RE: PCN # ESU270-80 - SOT23-5L/6L additional backend location approval

Device : SP3019-04HTG/SP0504SHTG/SP0504SHTG-ER/SP0504BAHTG/SP0505BAHTG

Revision : A

# 5.0 Physical Differences/Changes:

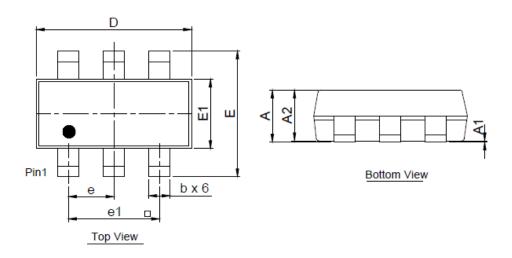
Symbol	Original		New			
Symbol	MIN	TYP	MAX	MIN	TYP	MAX
А			1.45			1.45
A1	0.000		0.15	0.000		0.15
A2	0.90	1.15	1.30	0.90		1.30
b	0.30		0.50	0.25		0.50
D	2.75	2.90	3.05	2.70		3.05
Е	2.60	2.80	3.00	2.60		3.00
E1	1.45	1.60	1.75	1.45		1.75
е	0.95 BSC		0.95 BSC			
e1	1.9 BSC		1.9 BSC			
L	0.30	0.50	0.60	0.30		0.55
